**MACC IV-23-1051198
Bldg 503 Mezzanine
Contractor Questions
14 Dec 2022**

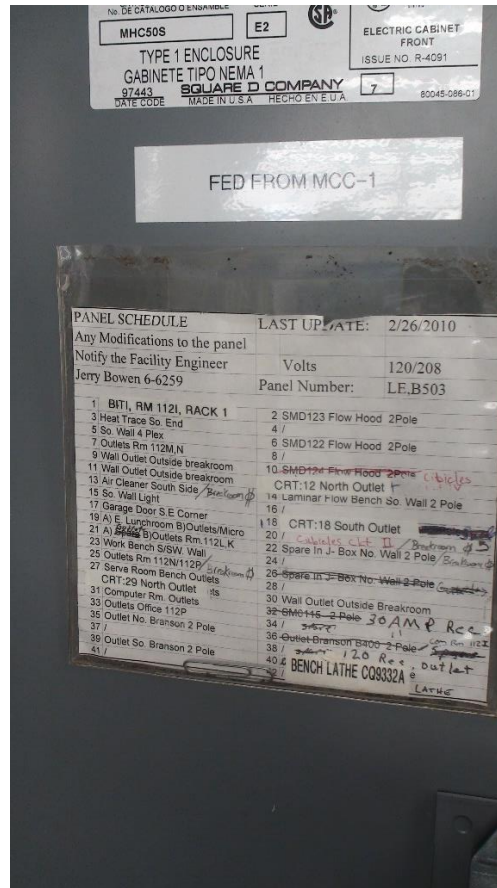
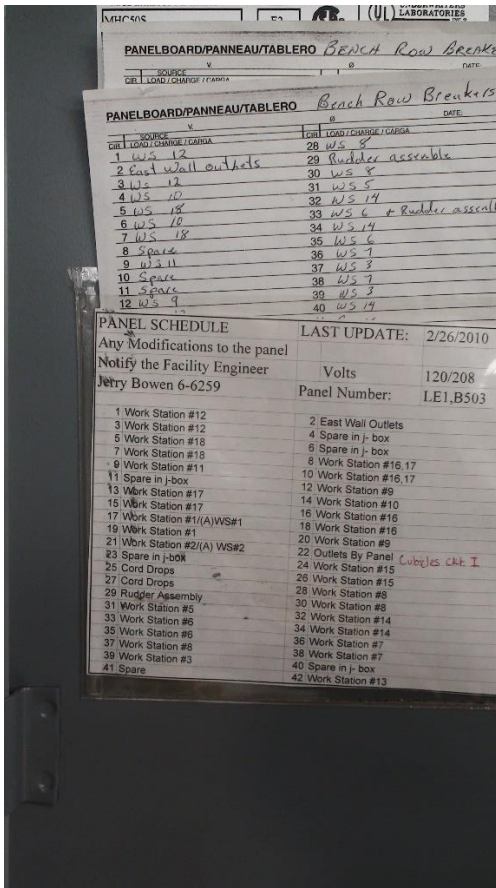
8. What is the existing lighting foot candles in the area where additional fixtures are stipulated in the SOW?

Response: Current lighting was tested, and ranges is between 65fc and 95fc. Target 85fc at workbench surface for new fixtures. Additional details available in UFC 3-530-01.

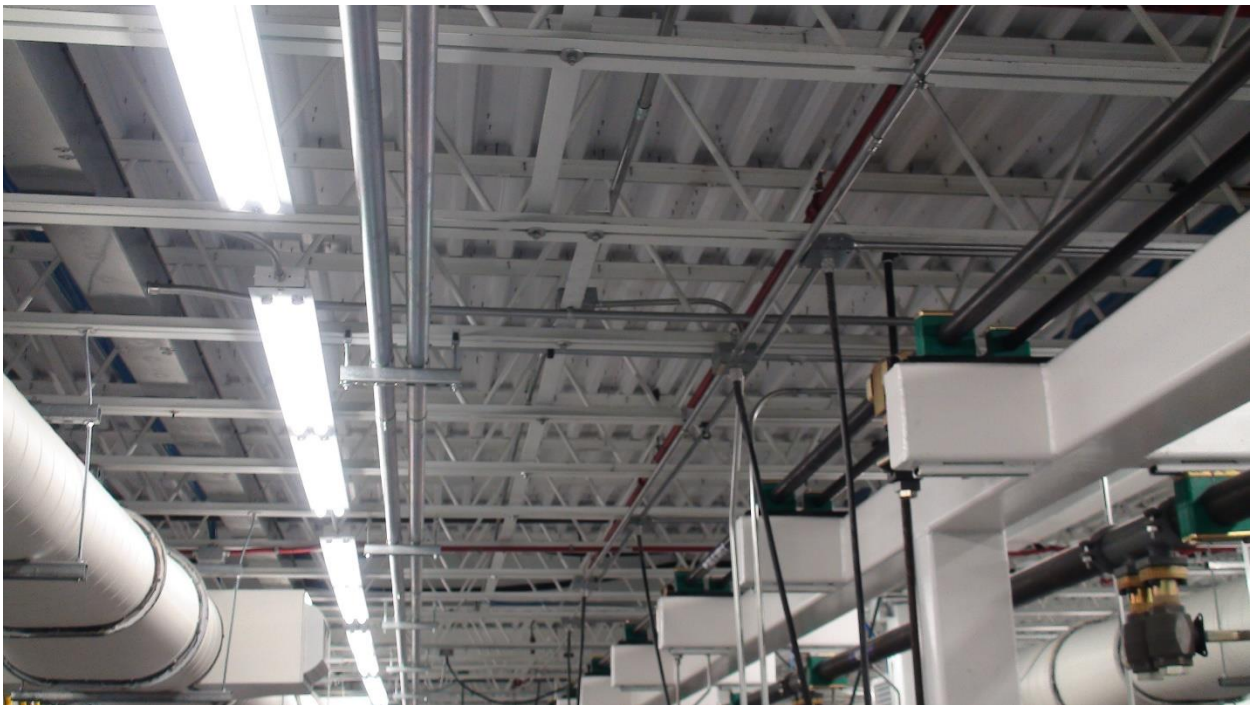
24. Would the government please provide pictures of the mezzanine deck from down below showing the deck, screws, supports, etc.

Response: See below

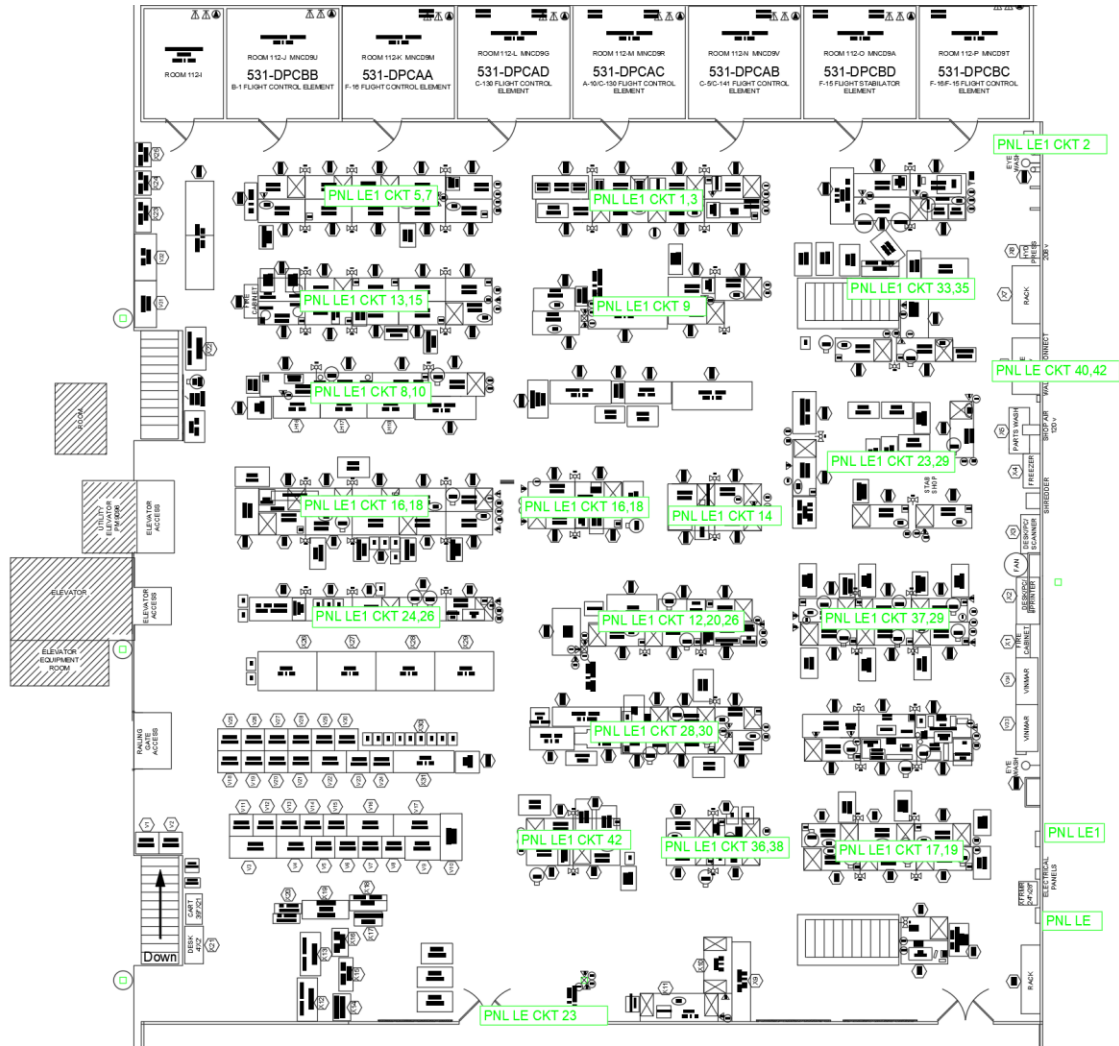
30. SOW page 5, section 2.17.6 says to “provide new carpet tile 18” x 18” typical” and that we are to match B503A. Will the government please provide pictures from building 503A that show the carpet we are intended to match?

Response: Please contact Jeff at FLOOR STYLES, INC. for details - (801) 281-4747. Records show carpet is called “Wine and Honey”, by Milliken, but may have been a custom color for USAF.

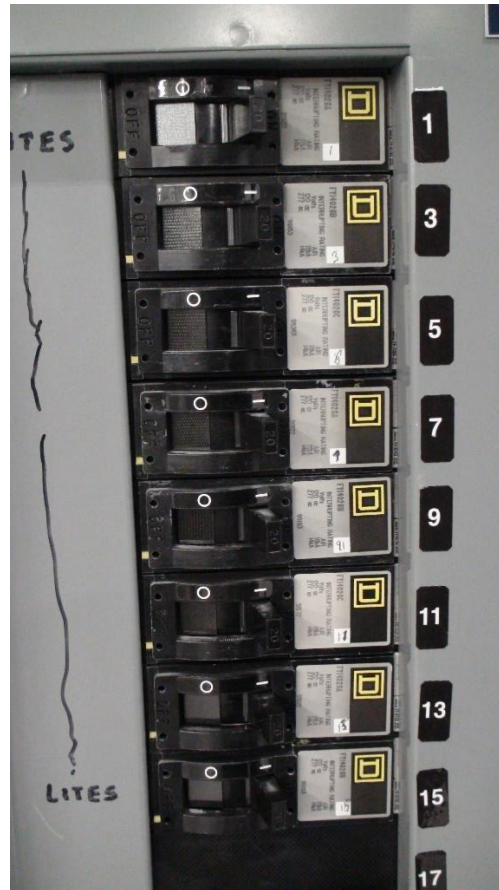
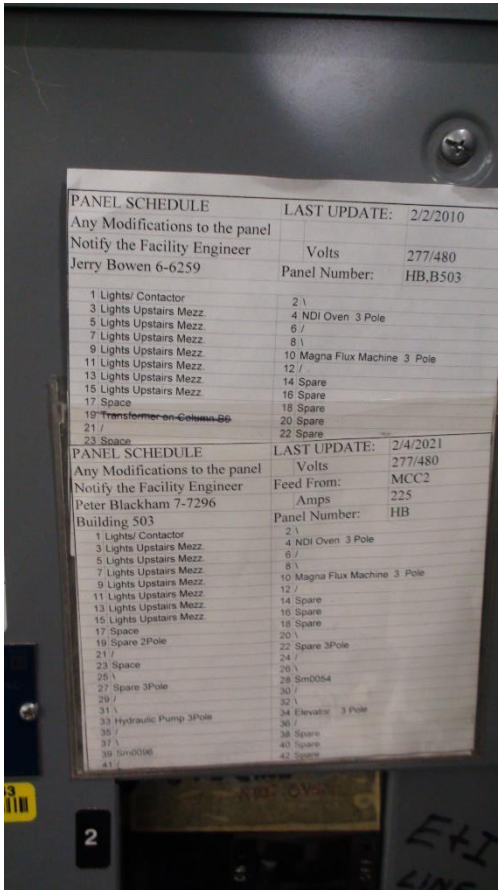
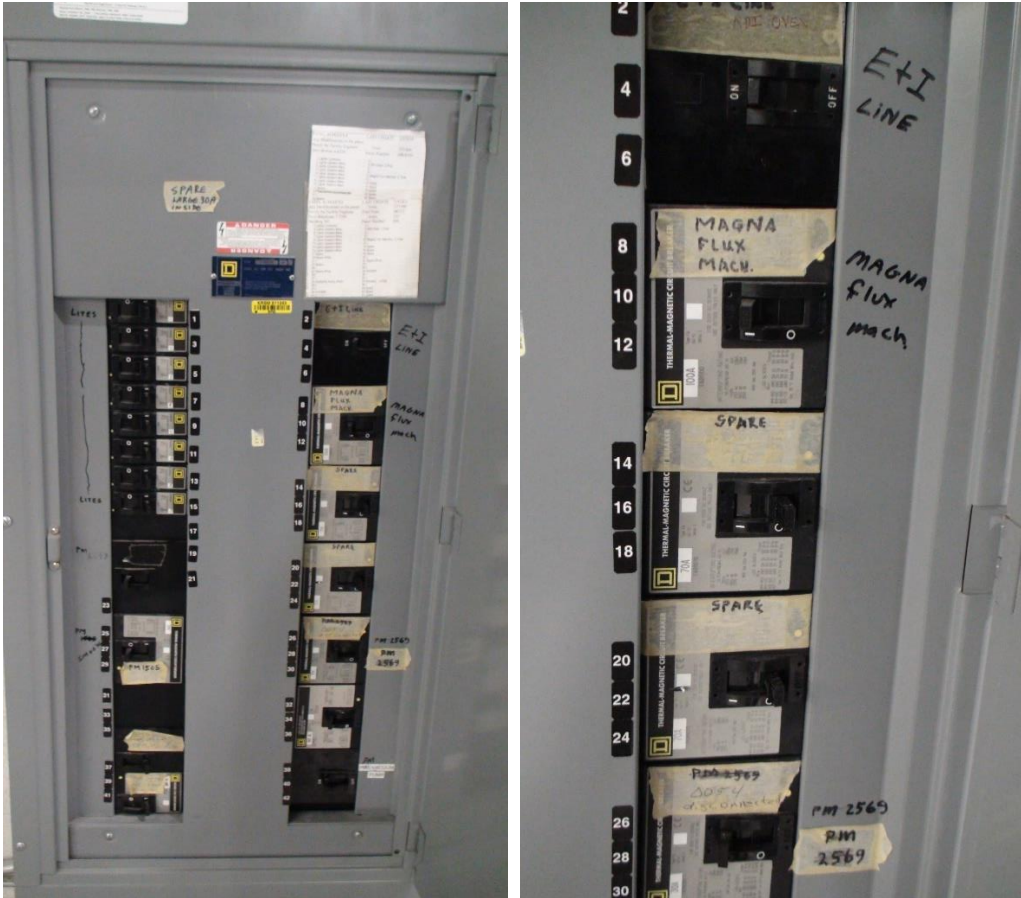
41. As the existing fixture layout will change nearly completely, please provide locations of the home runs for each row of existing fixtures, and the circuits if possible.

Response: Lighting fixtures are fed from panel HB. See below for panel schedule, pictures of circuits, and available spares in panel.
